TENDER ADDENDUM

Project: UHN Interventional Fluoroscopy Tender Addendum #:

University Hospital of Northern British Columbia

The following information supplements and/or supersedes the "Issued for Tender" drawings issued for the above project dated February 10, 2021.

PHASE 1 - INTER FLUORO MILLWORK SECTIONS

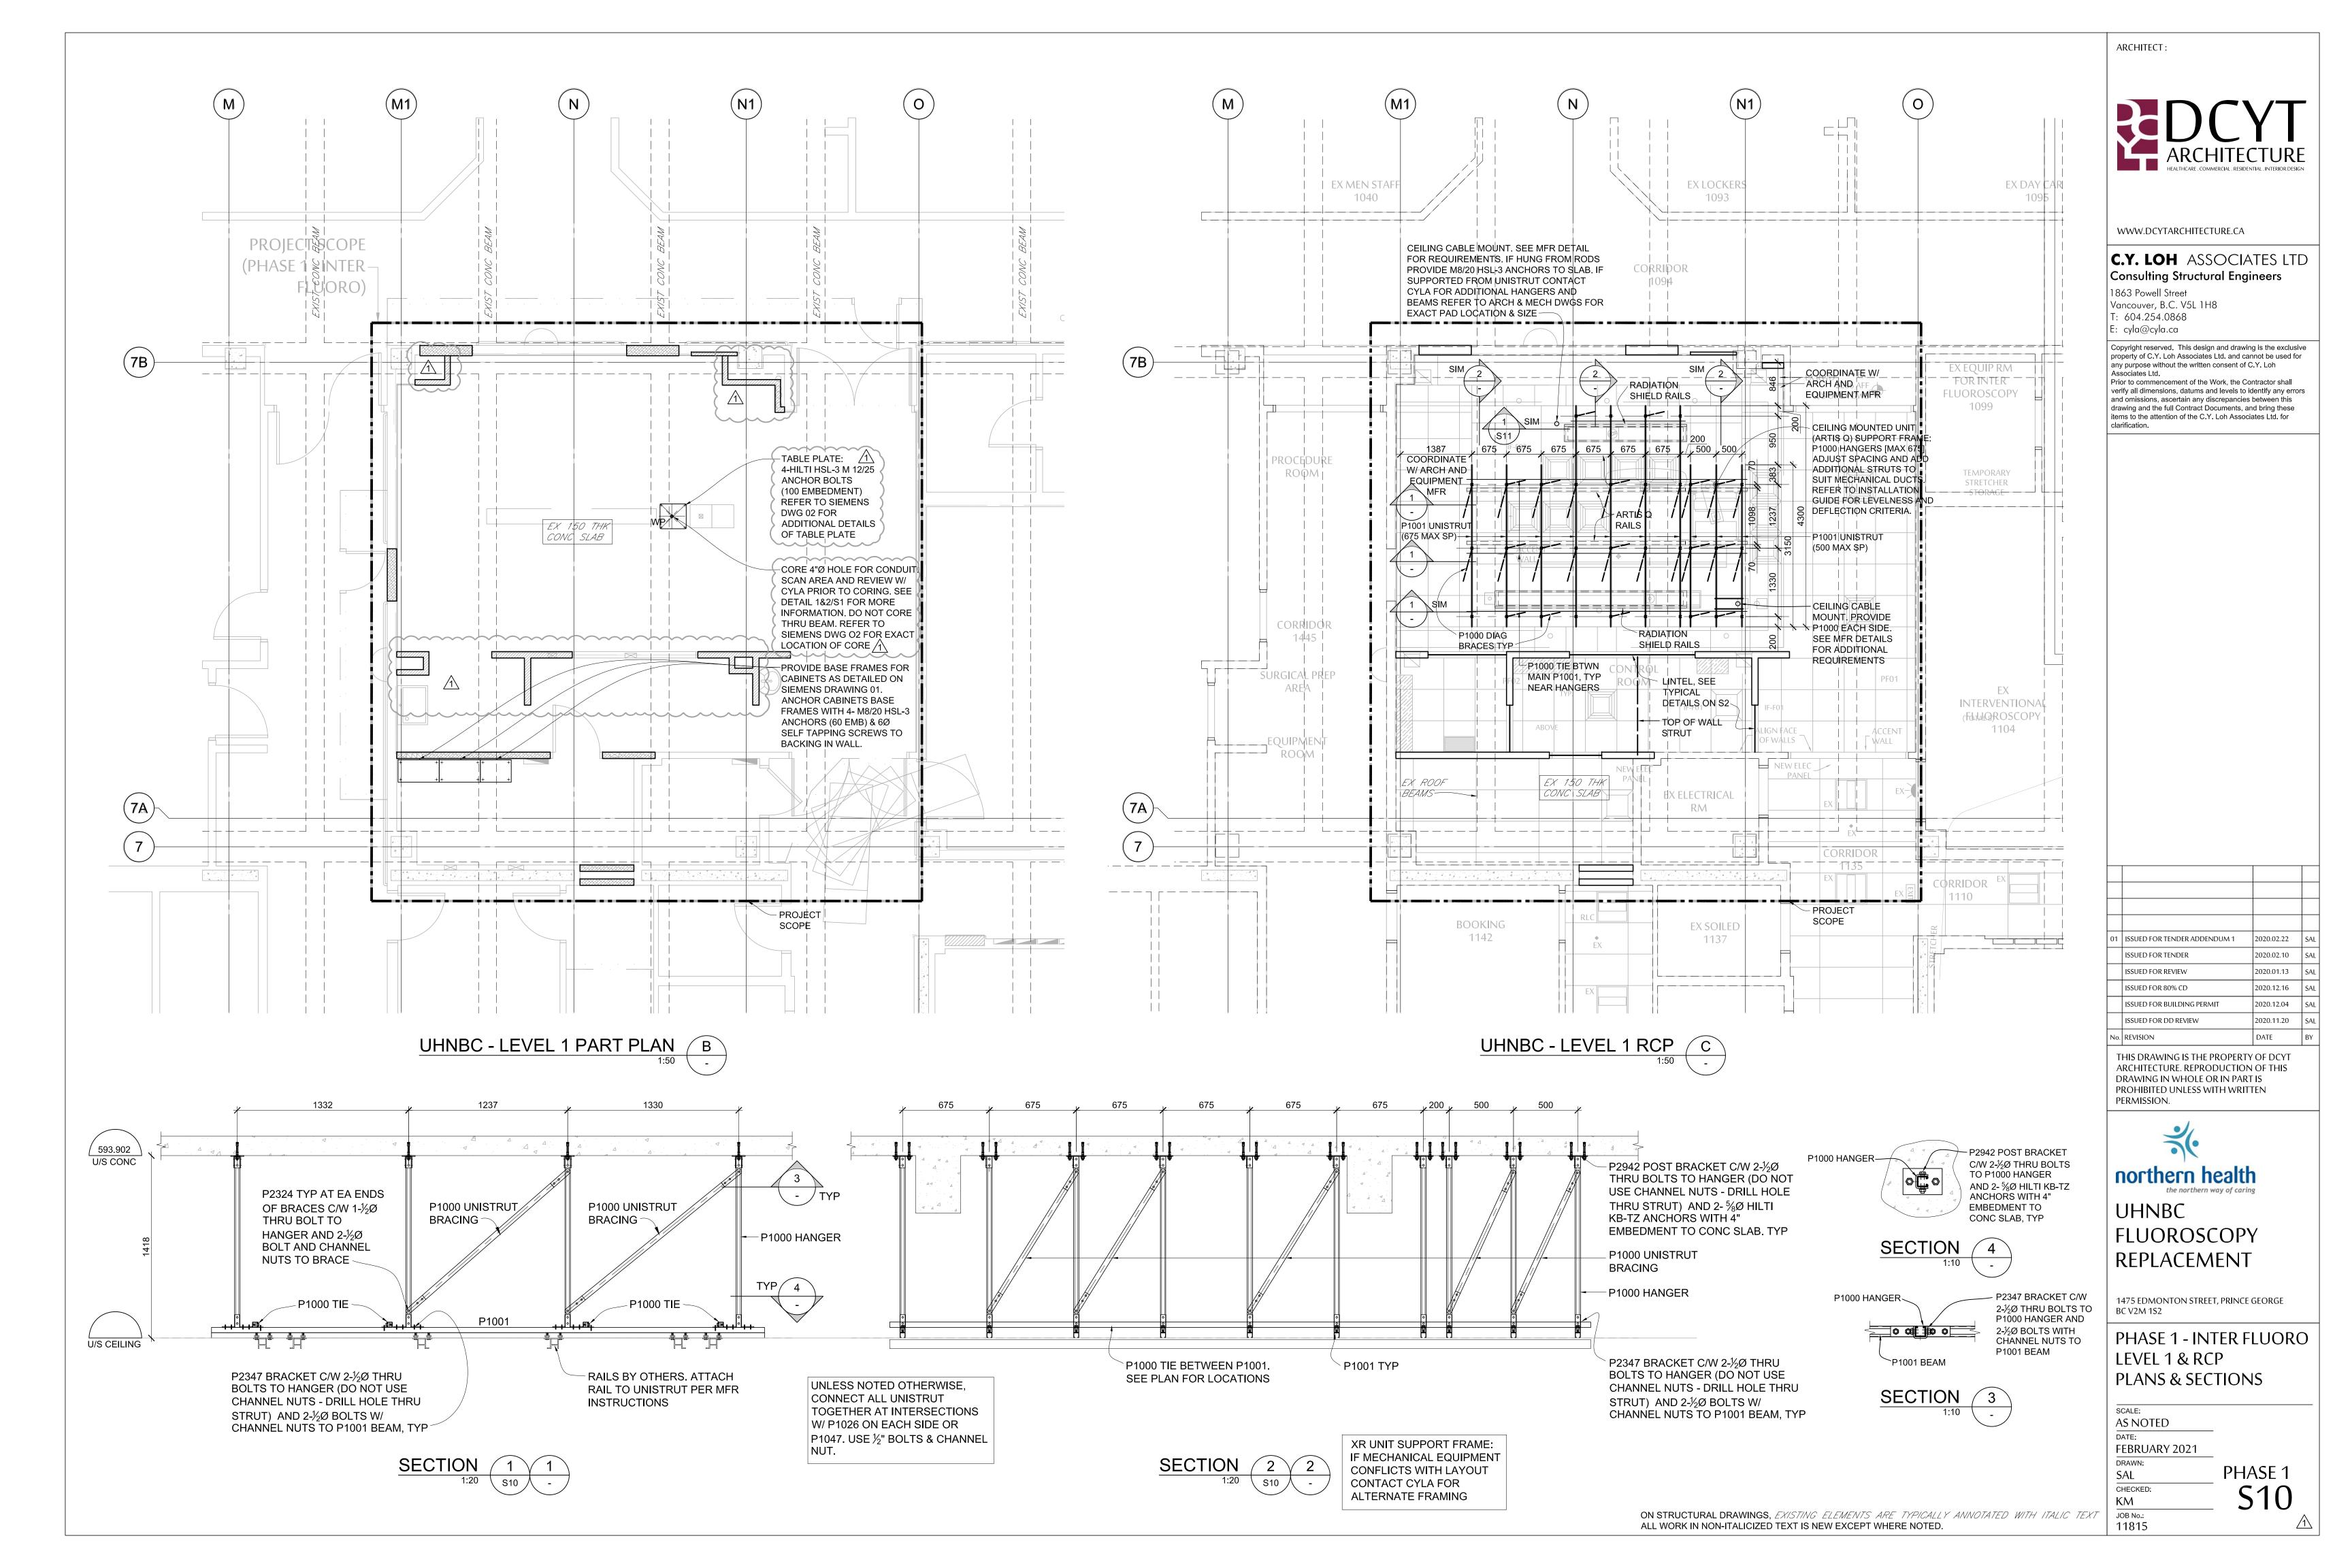
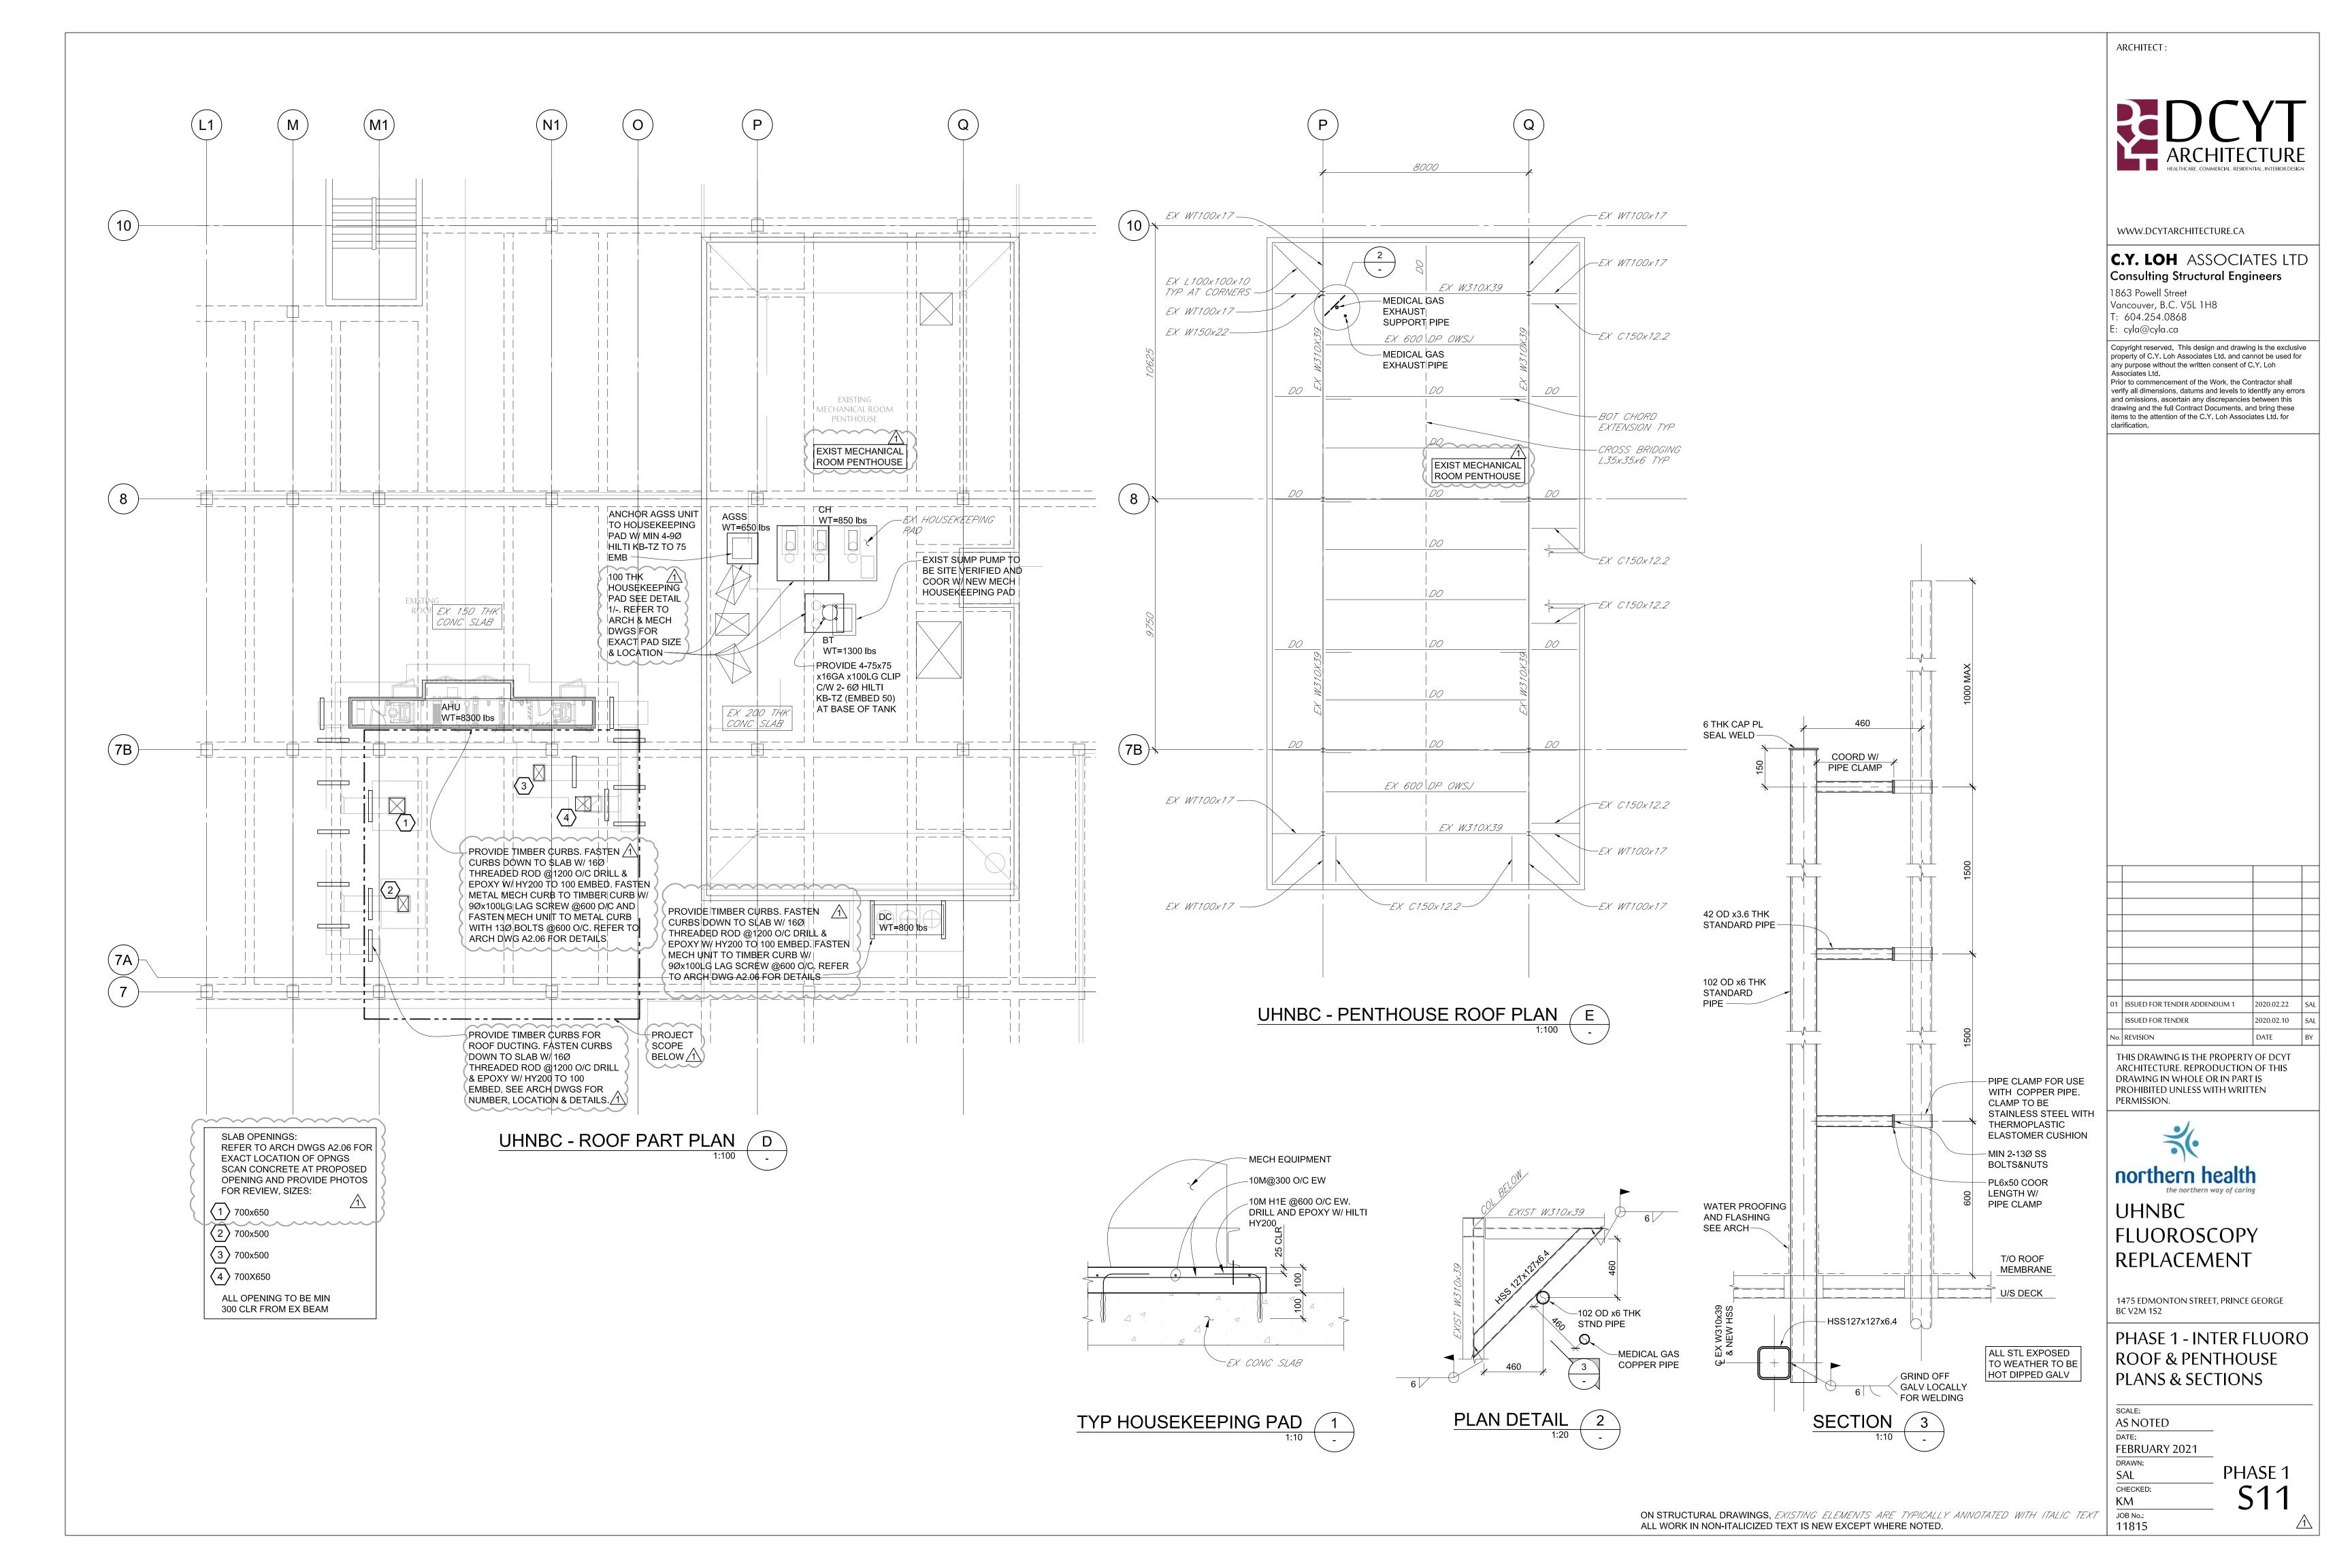
2.7.	See attached Dwg A5.02 – Door hardware, Finishes & Room Schedule, for revised door hardware schedule.	
2.8.	See attached Dwg A6.01 & A6.02 – Millwork, for millwork revisions.

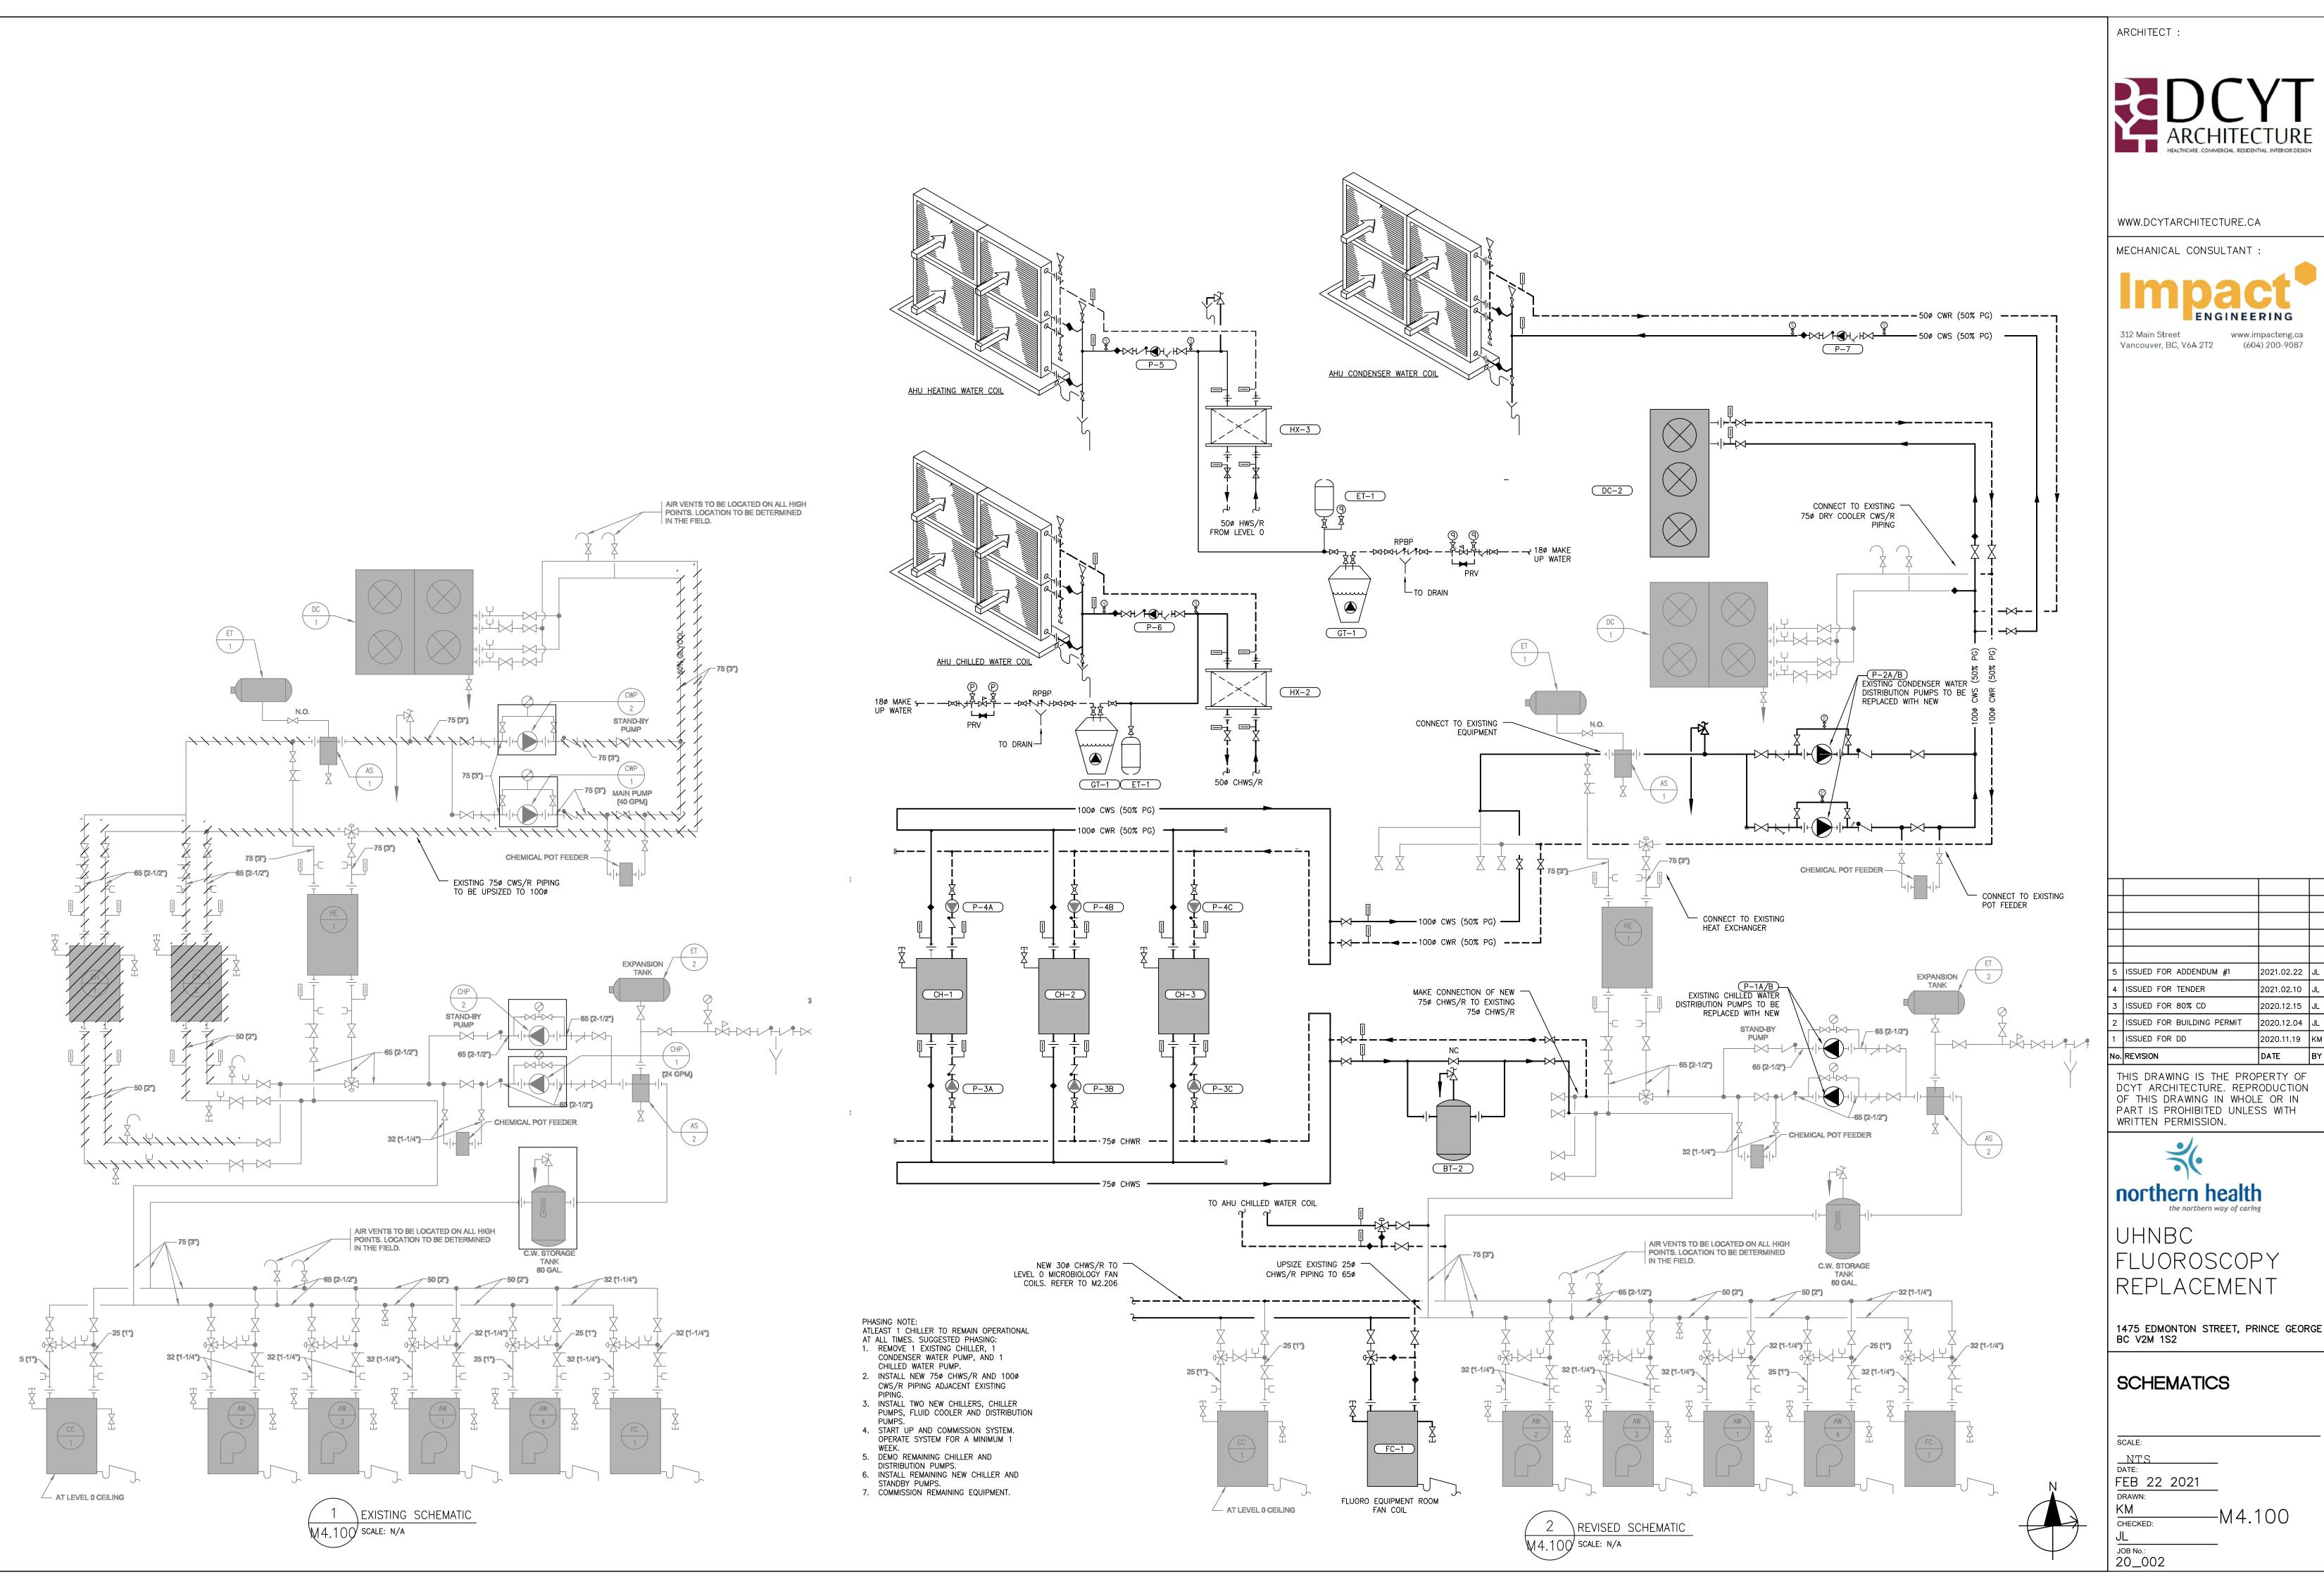
- 2. ADD: Drawing M4.100 Schematics
 - a. New equipment and piping connections shown on schematic
 - b. Phasing notes included to maintain operation of existing cooling system
- 3. ADD: Drawing M5.100 Schedules:
 - a. AHU Schedule and Cutsheet.
 - i. Refer to the attached document.
 - b. Anesthetic Gas Scavenging System.
 - i. Refer to the attached document.
 - c. Glycol and Expansion Tank.
 - i. Refer to the attached document.
- 4. NOTE: Drawing M5.200 Specifications
 - a. Controls
 - i. The base building controls contractor is Houle
 - Contact: Nick Hauff
 - Nick@houle.ca
 - ii. A cash allowance for the controls scope will be issued in the next addendum.
